ATTACHMENT 1
PROPOSED TECHNICAL SPECIFICATION CHANGE
SURRY POWER STATION UNIT NOS. 1 AND 2

DISCUSSION OF PROPOSED TECHNICAL SPECIFICATION CHANGES

TABULATION OF PAGES
PROPOSED TECHNICAL SPECIFICATION CHANGE
SURRY UNITS NO. 1 AND NO. 2

Offsite Organization for Facility Management and Technical Support.

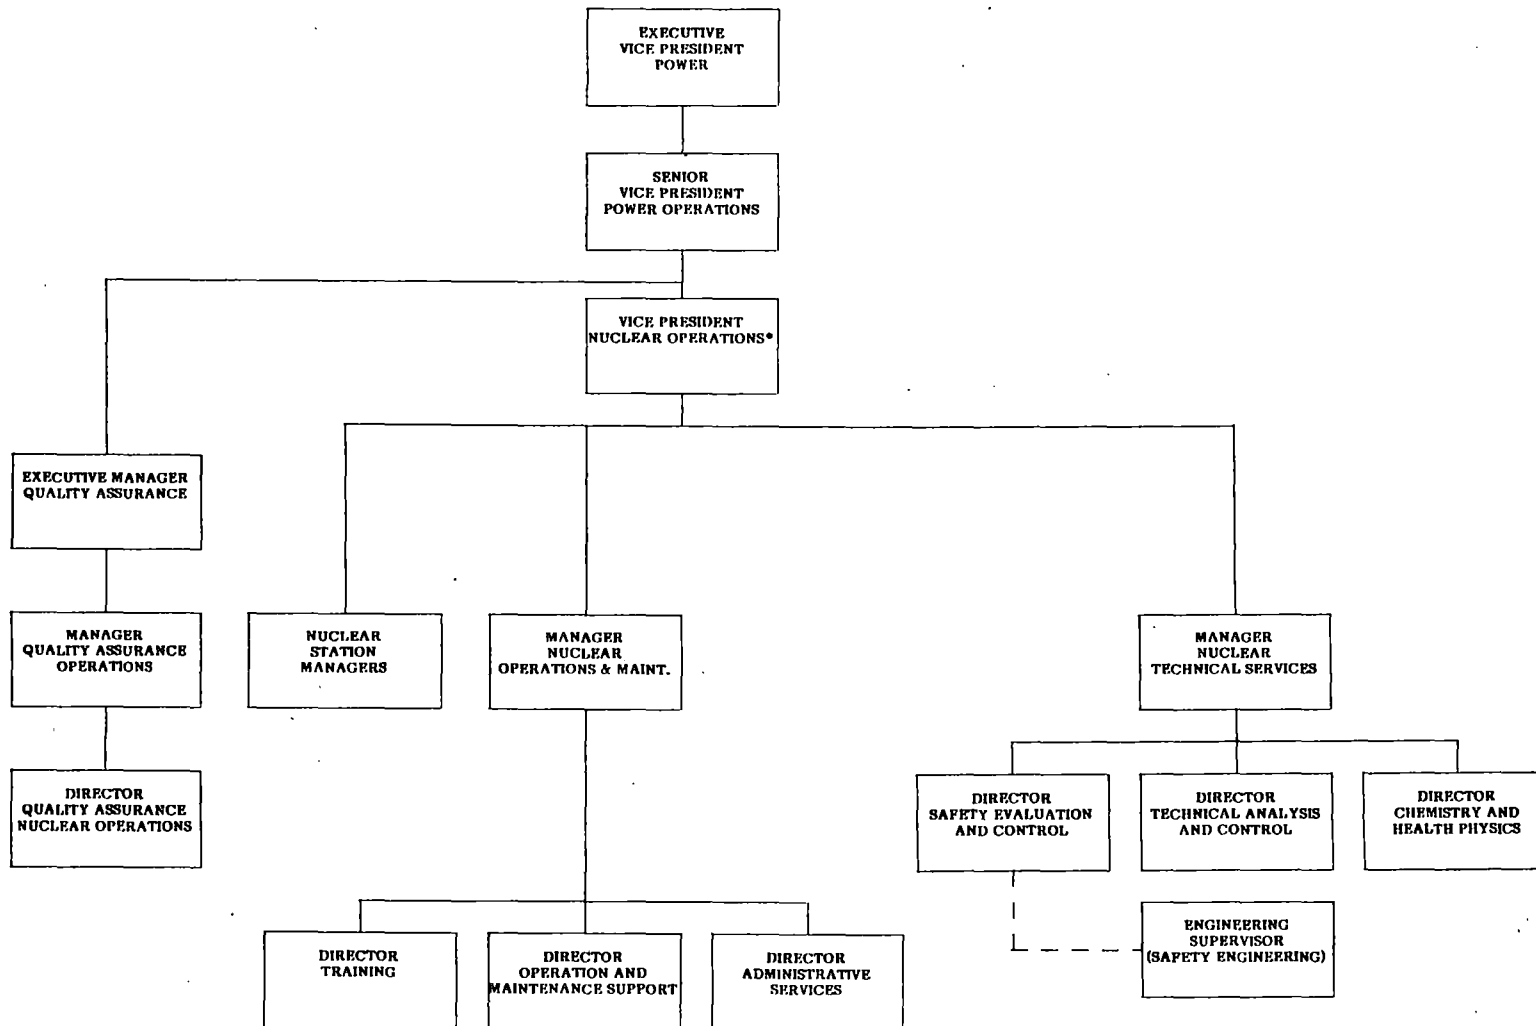
The proposed changes to the Technical Specifications reflect the reorganization and transfer of responsibilities within the Nuclear Operations Department from the Manager-Nuclear Operations and Maintenance to the Vice President-Nuclear Operations. The proposed changes are discussed below.

At present, the corporate organizational structure specified in the Technical Specifications indicates that the Nuclear Station Manager reports to the Manager-Nuclear Operations and Maintenance, who in turn reports to the Vice President-Nuclear Operations. As a result of the proposed revisions, the Vice President-Nuclear Operations will have responsibility for the supervision of the Nuclear Station Managers in the operation and maintenance of the Company's operational nuclear units. The Vice President-Nuclear Operations will also be responsible for coordinating the technical services activities and the operational maintenance activities of the nuclear units. The transfer of the supervision responsibilities to the Vice President-Nuclear Operations will provide continued assurance of adequate managerial involvement in the operational and maintenance activities of the nuclear units and will enhance managerial attention of safety activities for the units.
